PROJECT: Skimmerlin Village 21 Parcel J

CITY OF LAS VEGAS INTER-OFFICE MEMORANDUM

SUBJECT: Drainage Study for:

Summerlin Village 21 Parcel J

Worksheet for H3 MAX (Full Street)

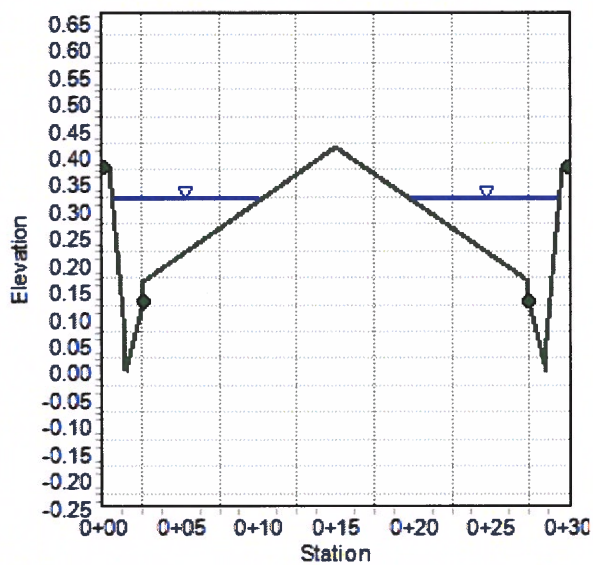
13. The calculations provided for cross section H3 uses a flow value of 5 cfs, while the proposed drainage map Exhibit E shows 4 cfs. Revise accordingly.

Facility P4: Q = 4 CFS

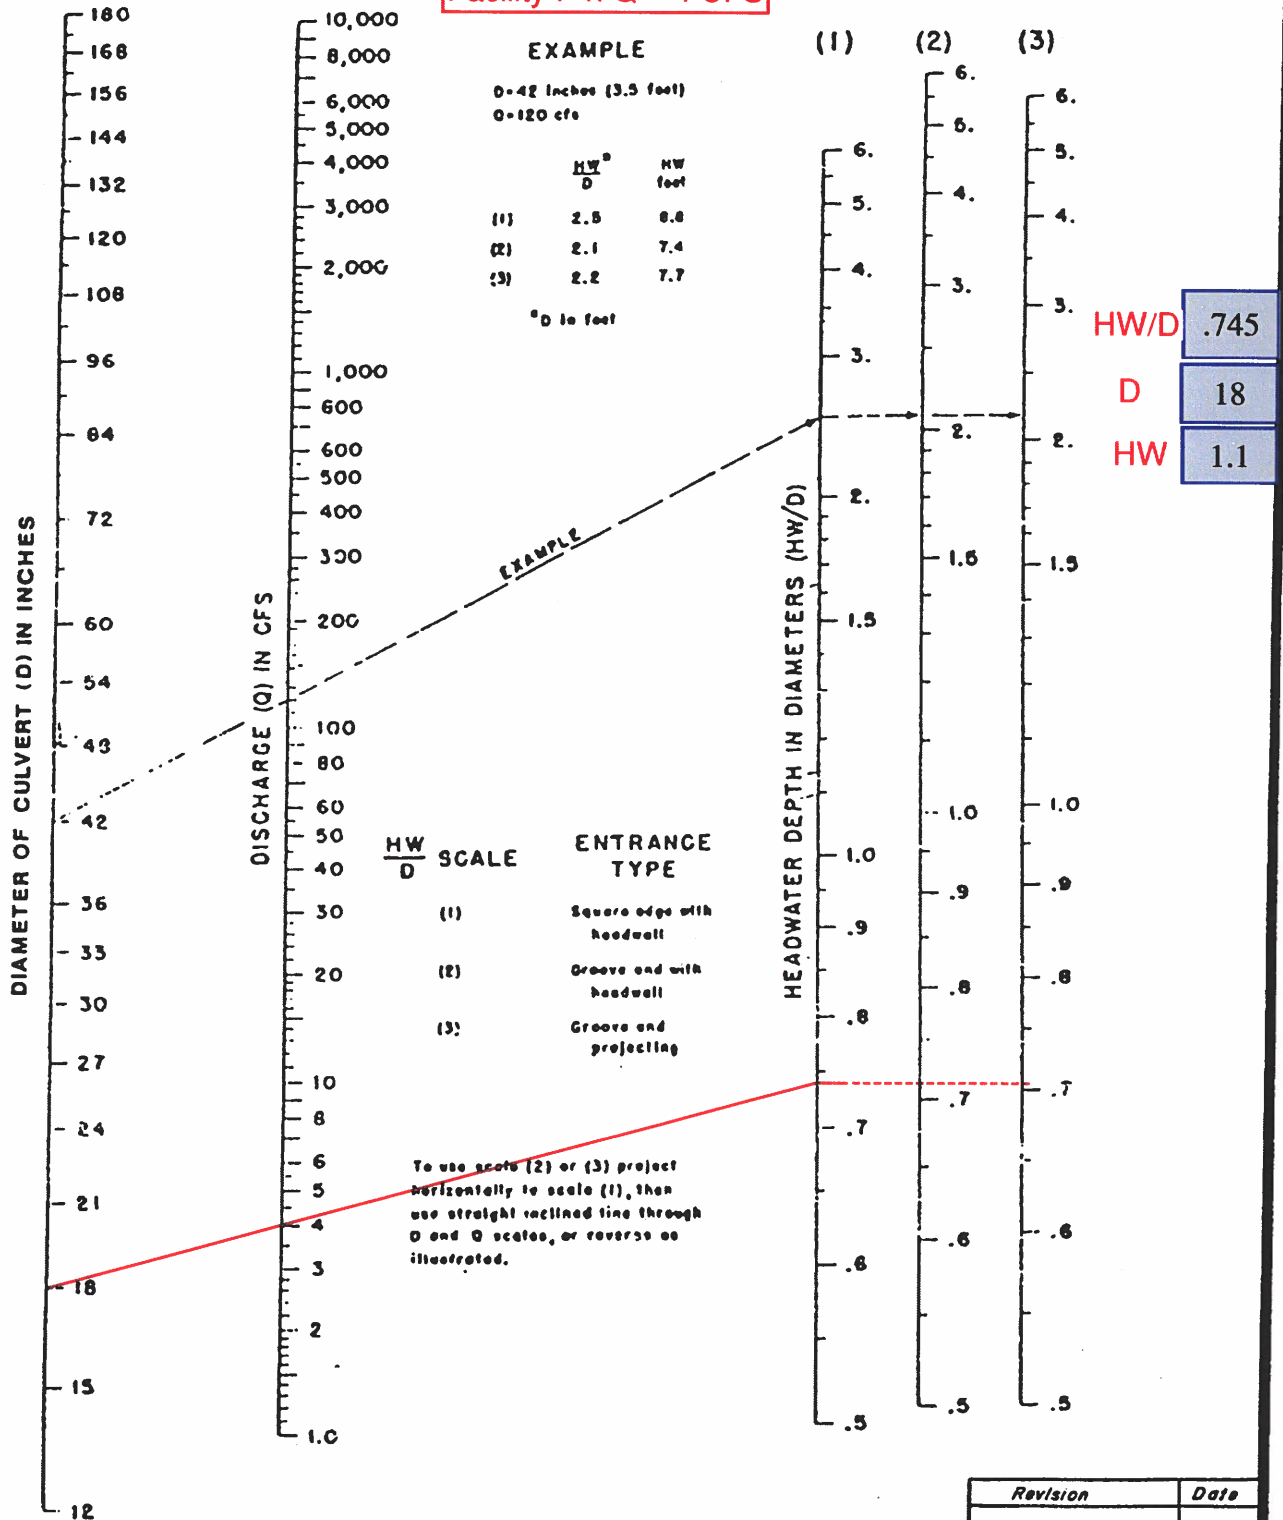
15. In Standard Form 6, the upstream and downstream inverts for the lateral storm line from inlet P4 does not match the inverts shown in sheet SD-3. In the sheet SD-3, the inverts are D/S = 3273.84 and U/S = 3274.07. Revise accordingly.

16. In Standard Form 6, lateral flows from inlets P4 and P6 are reported as non-pressurized. However, lateral storm lines from P4 and P6 are likely to be pressurized, based on the HGL shown in sheets SD-3 and SD-1, respectively. Standard Form 6 is not intended to analyze pressurized flows. *Add normal depth calcs.* (16)

G-1
SHEET 4 OF 13

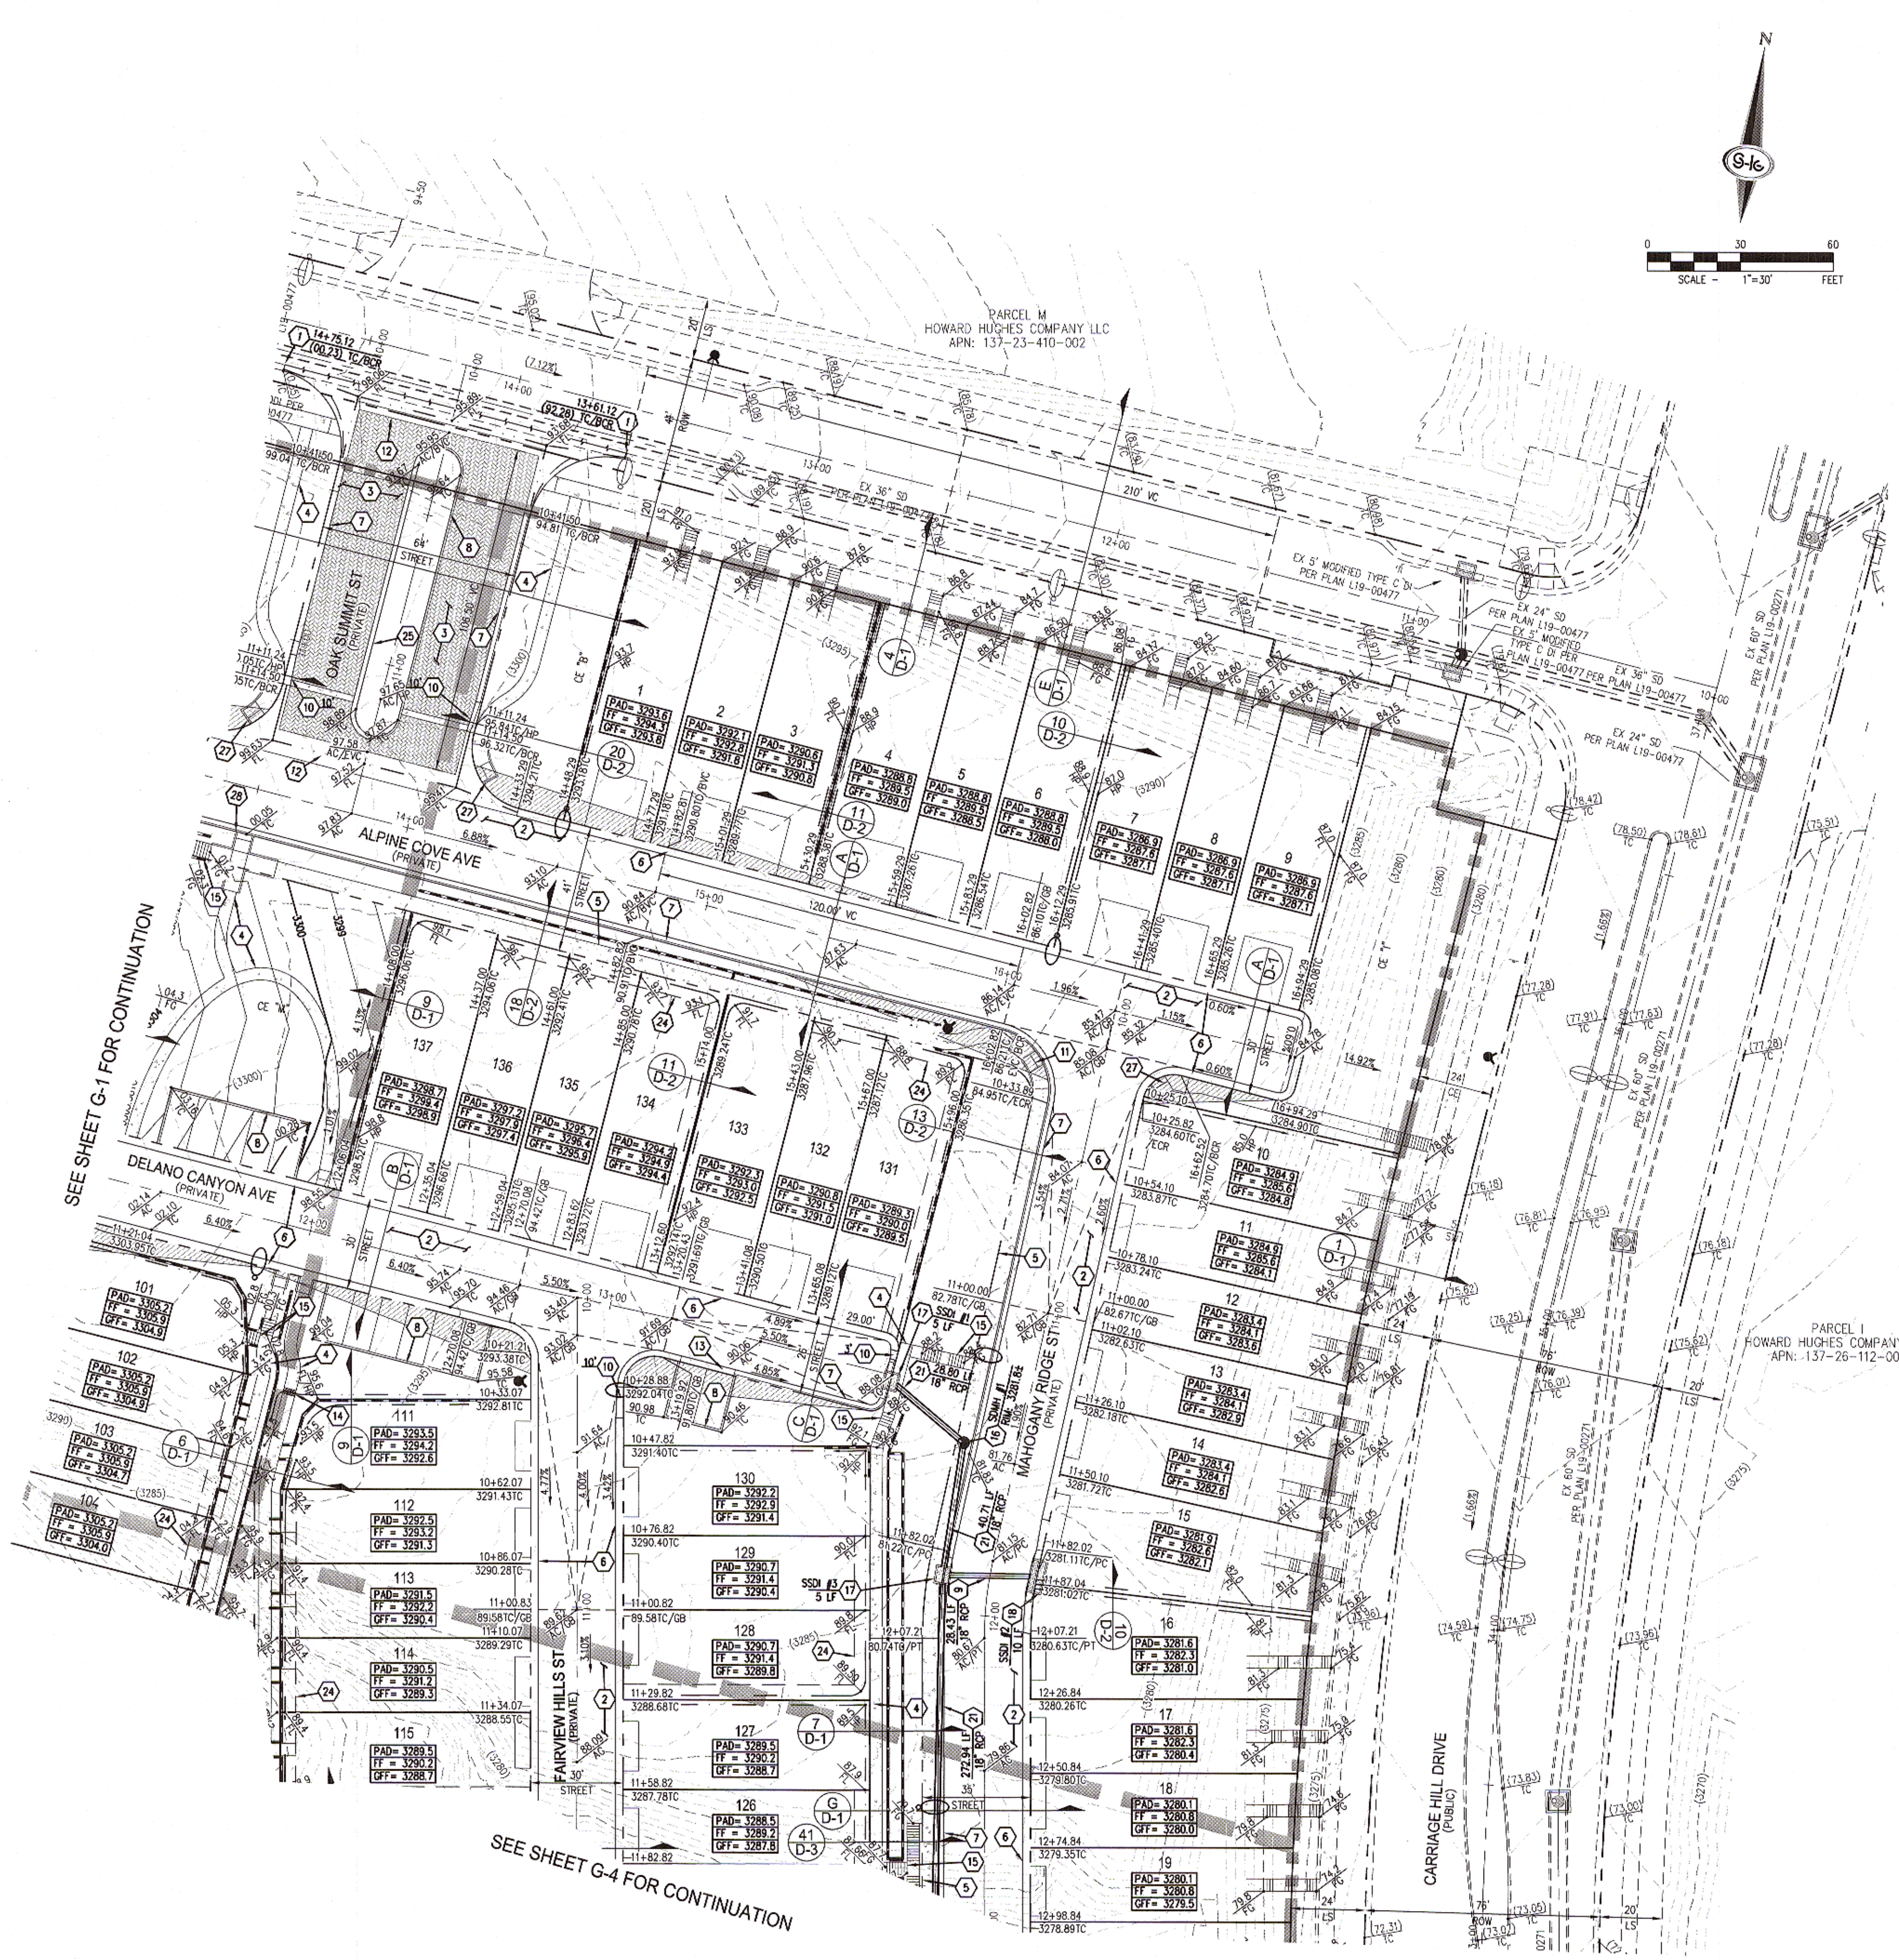
6. All Public Drainage Easements Drainage Easements to be Privately Maintained need to be shown on the associated cross sections. For example on Sheet G1 Section 21 D-2 a drainage easement is called out on the plans, but not shown in the cross section.
